**OPERATING AND SERVICE MANUAL
3466A
DIGITAL MULTIMETER**

MANUAL CHANGES

MODEL 3466A

Manual Part Number 03466-90001

Figure CS2. P/O Figure 4-9.

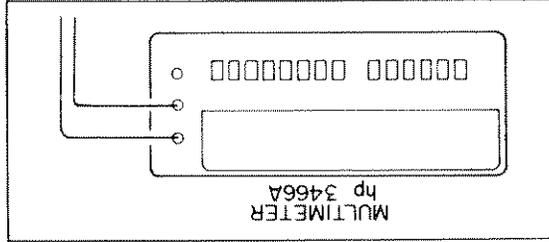
Page 4-7, Figure 4-9. Change the Multimeter connections as shown in Figure CS2.

Figure CS-4, P/O Figure 8-19.

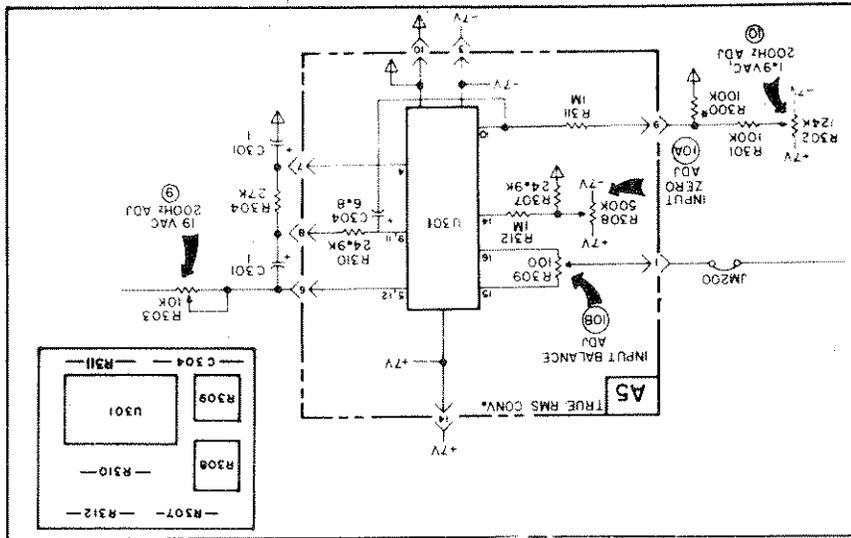
Page 8-21, Figure 8-19. In some instruments the True RMS Converter (U300 and associated components) will be replaced by the schematic shown in Figure CS-4. This figure includes the A5 PC assembly and its component locator.

Page 8-21, Figure 8-19. Change the value of R301 and 302 to 124 K and 500 K respectively. These components are located in two places on the schematic - near the A5 PC board assembly, and in the middle of Schematic No. 3

Figure CS-5, Add A4C907 and L901.

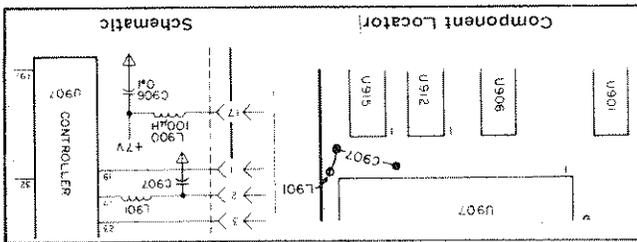
Page 8-23, Figure 8-20. Add C907 and L901 to the A4 Logic Board Schematic and Component Locator as shown in Figure CS-5.

Figure CS-7.

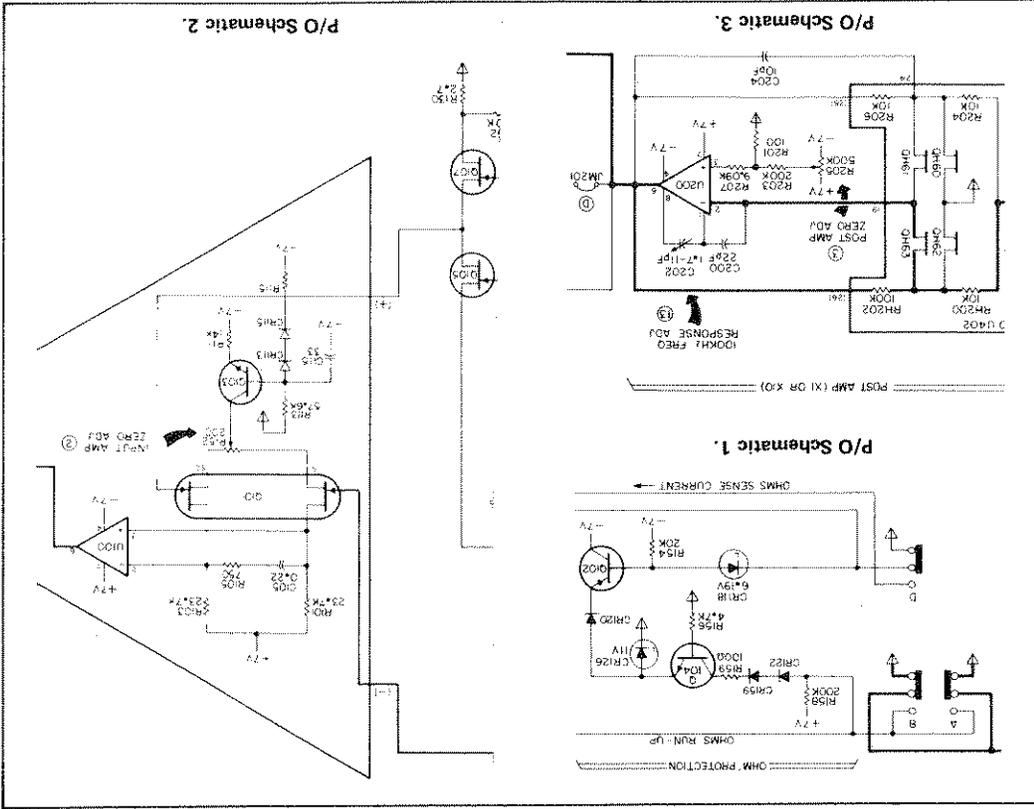
Page 8-19 and 8-21. Change Schematic 1, 2, and 3 as shown in Figure CS-7.

Figure CS-6. P/O A1SS.

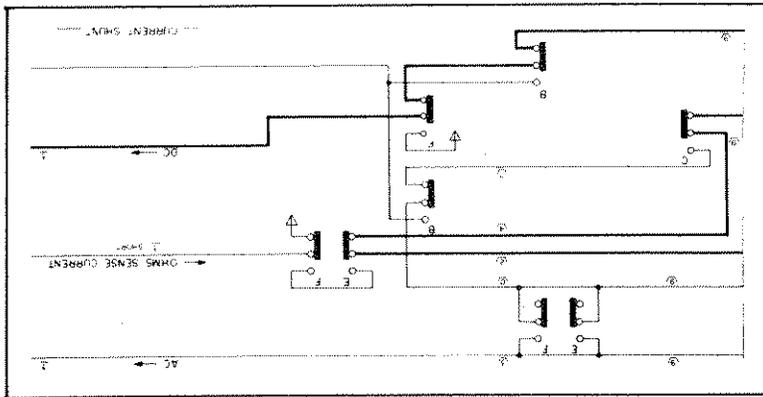
Page 8-17, Figure 8-17. Add section F to SS as shown in Figure CS-6.

Figure CS-1.

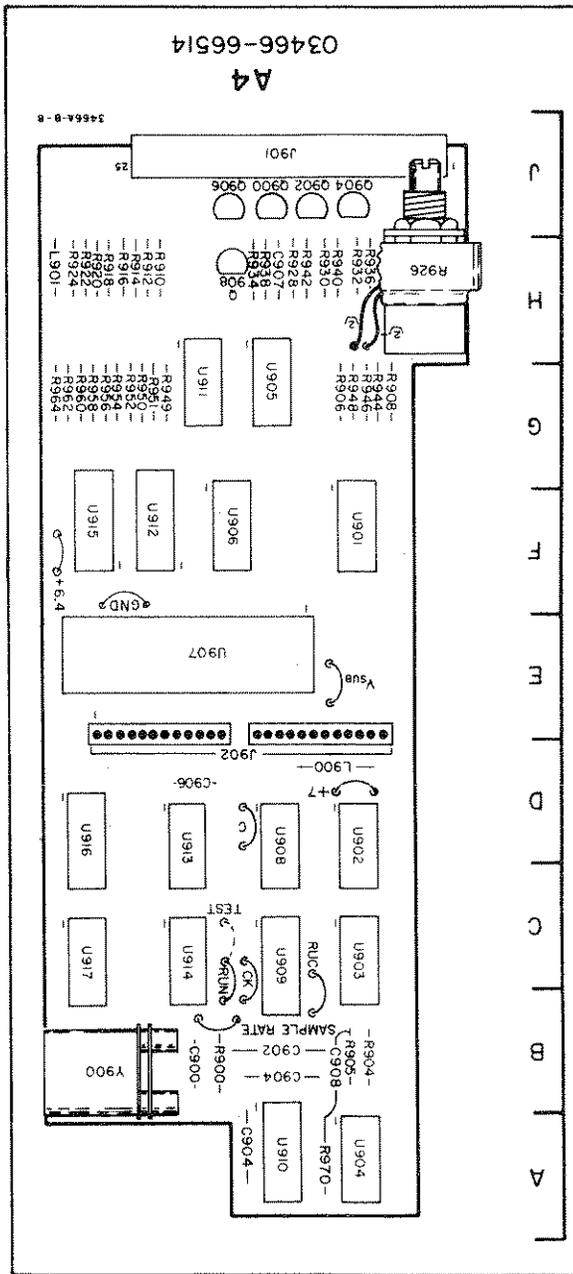
Page 8-23, Figure 8-20. Change the A4 component location as shown in Figure CS-1.
 Page 8-25/8-26, Figure 8-21. On the A1 schematic drawing for the power supply, change the destination of the Vsub (-2/6) power supply from 1, 2 to 3. Change the destination of the Vdisp power supply to 3, 4.

Figure CS-2.

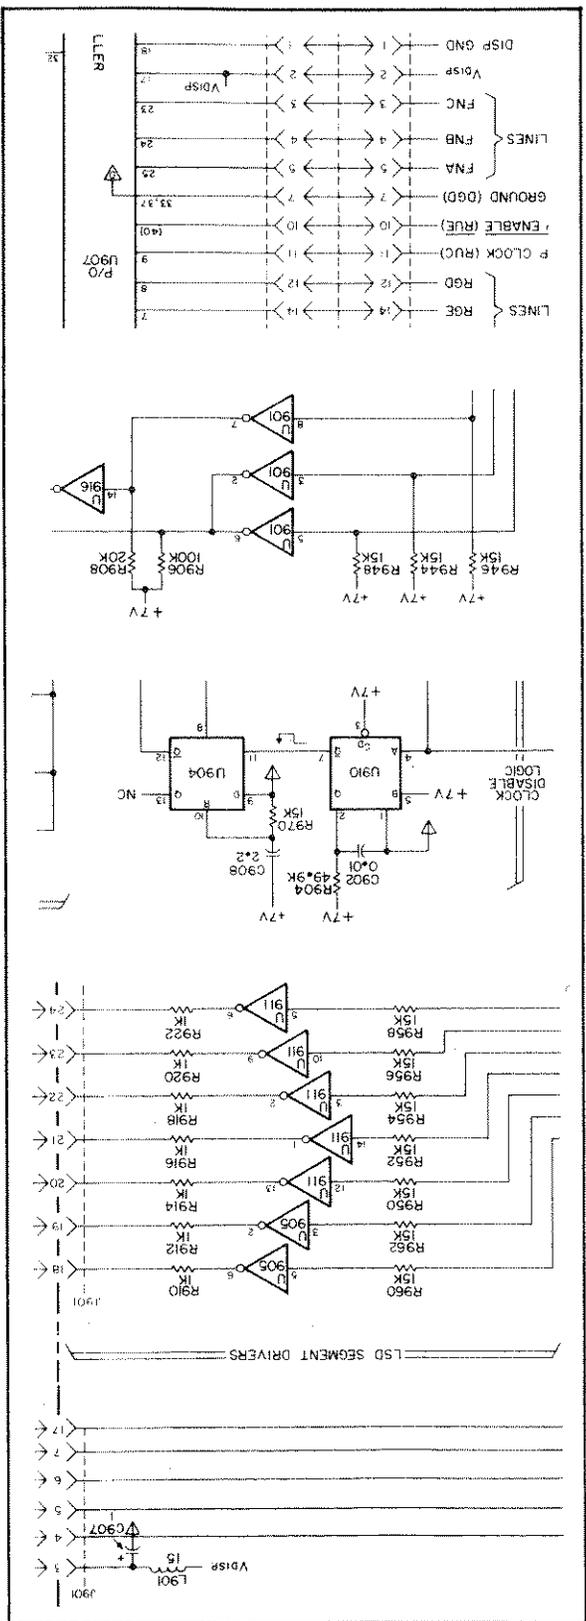
Change the A4 schematic drawing as shown in Figure CS2.

Figure 3-2. Battery Voltage Access Hole.

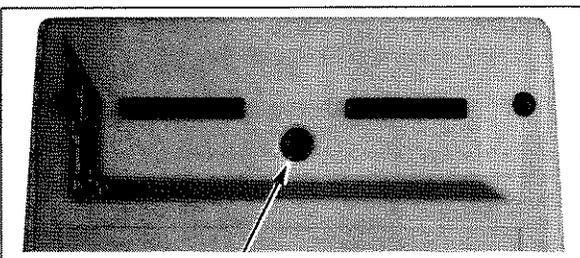
Page 3-2, Figure 3-2. Change 1700.0 V (Max) to 1200.0 V (Max) and delete the ["*"] above that input level.

Figure 3-4. Multimeter Autoranging.

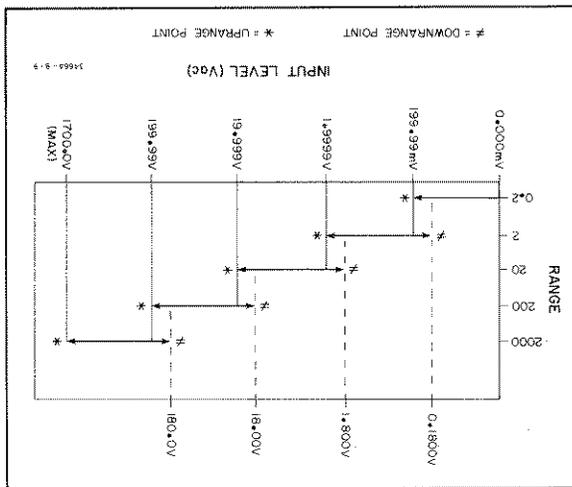
Page 3-2, Paragraph 3-14. Change the second to last sentence to read: "Figure 3-4 shows the autoranging points of ac voltage measurements from 0 to 1200 V ac."
